Access Compliance Report Public Rights-of-Way (Curb Ramps)

Main Street: HYDE_PARK_DR		Cross Street: ARROYO_AVE		Location:	N
ADA ID: RPRK211228135830	Ramp Type: Type 4 - Parallel	Initial Pass/Fail: Fail	Overall Compliance: No	Severity Score:	16
Codes/Mitigation Info/Possible Solution			Field Measurements/Component Compliance

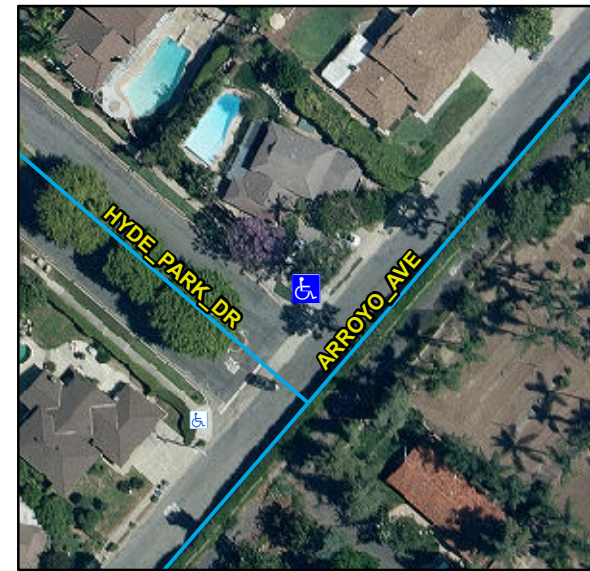
R304.5.3, R304.3.2, STD 1115

Remove & Replace Curb Ramp With Two New Directional Ramps or Equivalent.
